## Service Bulletin

SEB90-1  
Revision 3**TITLE**

MAIN LANDING GEAR PIVOT INSPECTION

**SK172-151**

Figure 1. Main Landing Gear Pivot Assembly (Sheet 2)

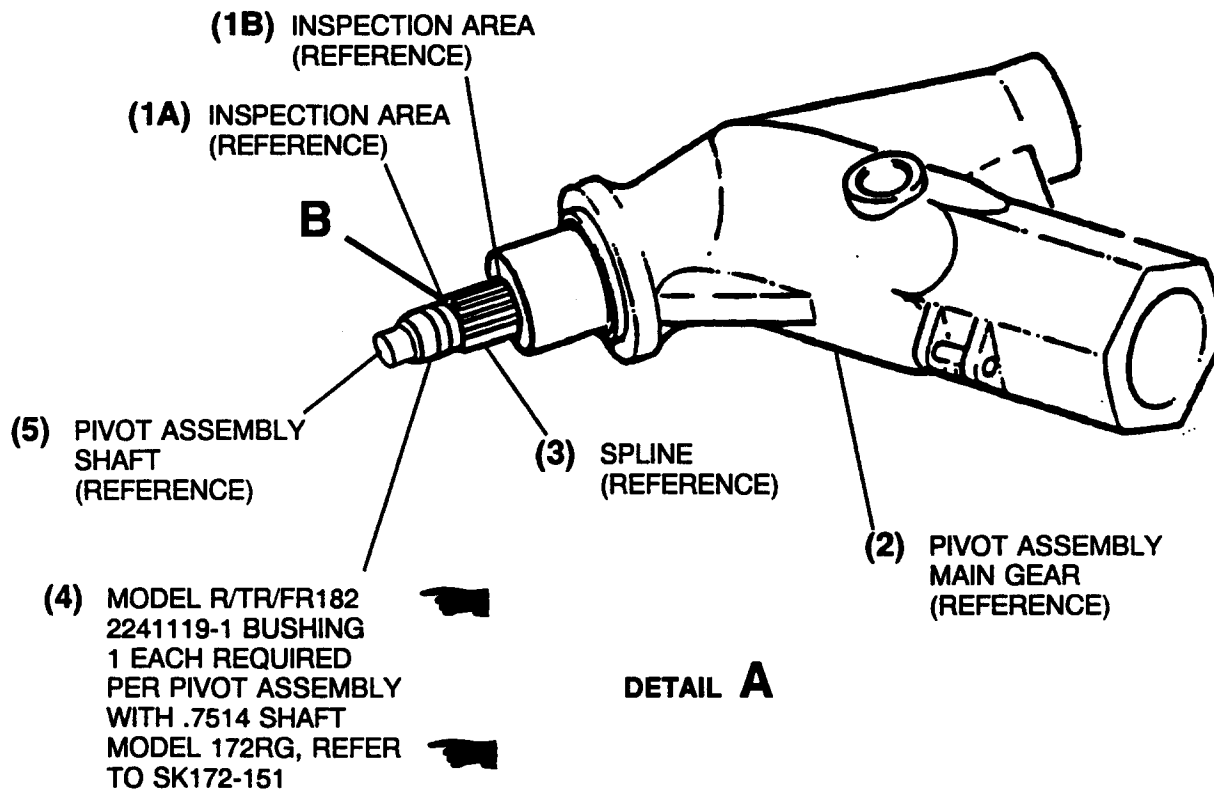
4. (Refer to Figure 1, Detail A, Sheet 2.) Remove both right and left main landing gear springs with pivot assemblies (2). Removal of both right and left wheel assemblies may be required to remove the main landing gear springs. Refer to section 5 of the appropriate Service Manual for removal procedures.

5. Remove bushing (4) from pivot assembly shaft. Use a vise-grip type pliers or suitable tool to remove press fit bushing. Removal of bushing is required to inspect area (1A) between bushing (4) and spline (3). Discard bushing.
6. (Refer to Figure 1, Detail A, Sheet 2.) Perform a fluorescent penetrant inspection in areas (1A & 1B) on each pivot assembly as follows:
  - a. Using a magnifying glass inspect the radius of area (1A) for burrs that may be present as a result of the press fit bearing installation. If the inspection reveals the presence of a burr, continue with Step b. If the radius is free of burrs, continue with Step c.

**CAUTION:** SANDING OR FILING ON SHAFT OR IN SHAFT RADIUS IS NOT ALLOWED. SANDING OR FILING WILL CAUSE PARTS TO BE UNDERSIZE AND REQUIRE REPLACEMENT. ONLY THE DEBURR TOOL IS ALLOWED TO BE USED FOR BURR REMOVAL.
  - b. Using part number 1820085-1 Deburr Tool (6), remove the burr in the radius of area (1A). Place tool on pivot shaft per Detail B and rotate completely around shaft to shave off burr.
  - c. Clean each pivot assembly (2) in inspection areas (1A & 1B) with ZC-7 Cleaner using a lint free cloth.
  - d. Apply ZL-22 Penetrant to the areas previously cleaned in Step c. and allow penetrant to remain on these areas for thirty minutes.
  - e. Clean the penetrant from the pivot assemblies using a clean lint free cloth dampened with ZC-7 cleaner. The inspection area is considered clean with a absence of background fluorescences.

Figure 1. Main Landing Gear Pivot Modification (Sheet 1 of 2)

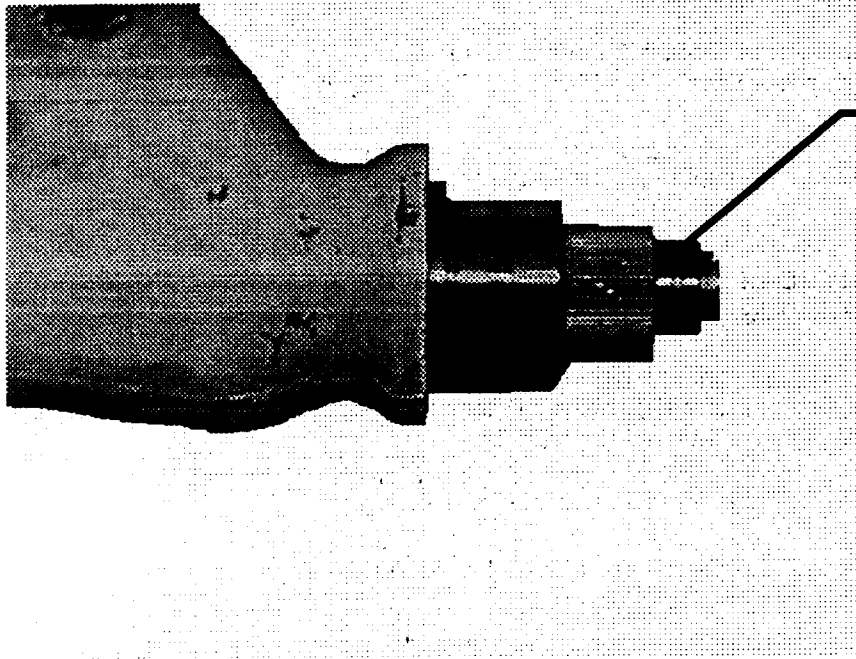
1. Remove Main Landing Gear Pivot. (Refer to Model 172RG Series Service Manual.)
2. (Refer to Figure 1, Detail A.) Remove and discard existing bushing from Main Landing Gear Pivot.
3. Inspect Main Landing Gear Pivot per Cessna Service Bulletin SEB90-1 Revision 3 (or latest revision).

REMOVE EXISTING  
BUSHING

Figure 1. Main Landing Gear Pivot Modification (Sheet 2)

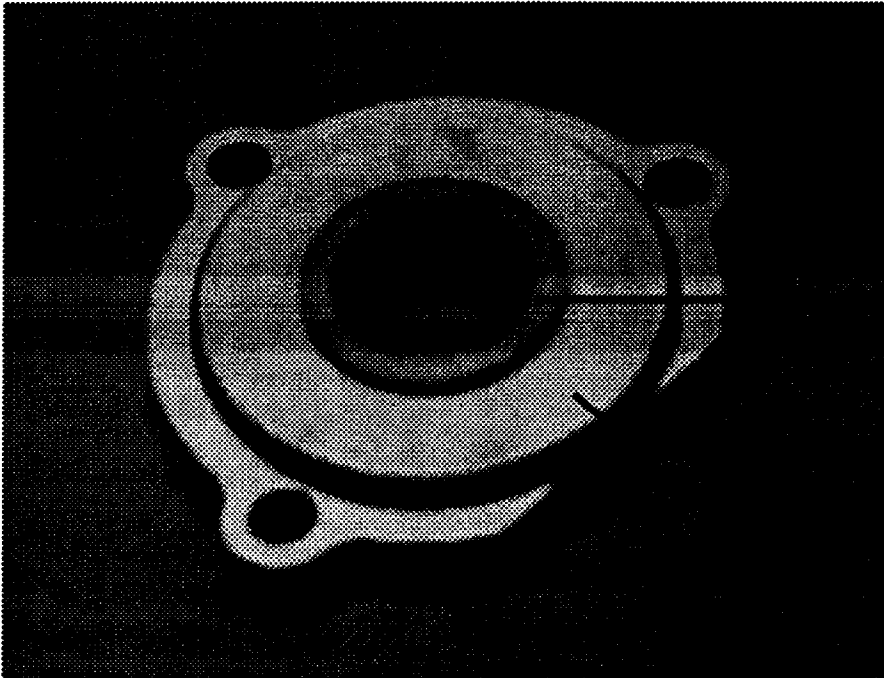
4. (Refer to Figure 1, Detail D.) Remove 9882003 Actuator Cap from Main Landing Gear Actuator.
5. (Refer to Figure 1, Detail C.) Remove bushing from 9882003 Actuator Cap.
6. (Refer to Figure 1, Detail D.) Install 2490002-1 or 2490002-2 Bushing in 9882003 Actuator Cap. Secure 2490002 Bushing to 9882003 Actuator Cap by applying a thin, even coat of EC1300L Adhesive to both surfaces. Ensure 2490002 Bushing flange is installed to inboard side of actuator cap.

**NOTE:** The 2490002-1 Bushing has a 0.75 inch inside diameter. The 2490002-2 Bushing has a 0.85 inch inside diameter. Select 2490002-1 or 2490002-2 Bushing to be glued into 9882003 Actuator Cap, as required, to fit over pivot in place of removed bronze Bushing.

8. (Refer to Figure 1, Detail D.) Reinstall 9882003 Actuator Cap onto Main Landing Gear Actuator. Reinstall brakeline fittings and brake lines. Bleed Brakes. (Refer to Model 172RG Series Service Manual, Section 5.)

**NOTE:** REGARDLESS OF  
BUSHING CONFIGURATION,  
REMOVE ALL BUSHINGS  
FROM ACTUATOR CAP.

ENSURE NON-FLANGED  
END OF 2490002  
BUSHING IS VISIBLE  
THROUGH ACTUATOR  
CAP AFTER  
INSTALLATION.
